# Service-Information Motorcycle

Fuel Tank  
and Lines

16 016 91  
(2486)

## Fuel Cap - All Boxer Models

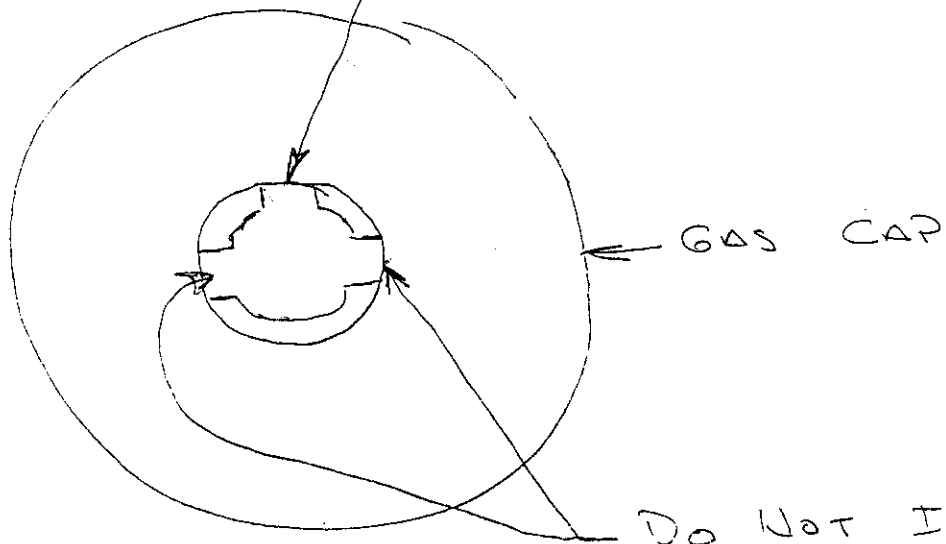
**Condition:** The fuel cap chafes the painted surface of the tank at the filler neck.

**Cause:** The filler neck is welded too deeply into the fuel tank.

**Remedy:** Install an O-ring - part no. 62 16 1 459 608 - into the groove of the fuel cap seal. The O-ring makes the seal slightly thicker and the cap cannot be screwed in as far.

LOCKING TANG OF LOCK  
MUST GO IN ON THIS RAMP

DO NOT INSERT  
LOCK DOWN THESE  
SIDE PIECES WITH  
THIN RIBS AT BOTTOM
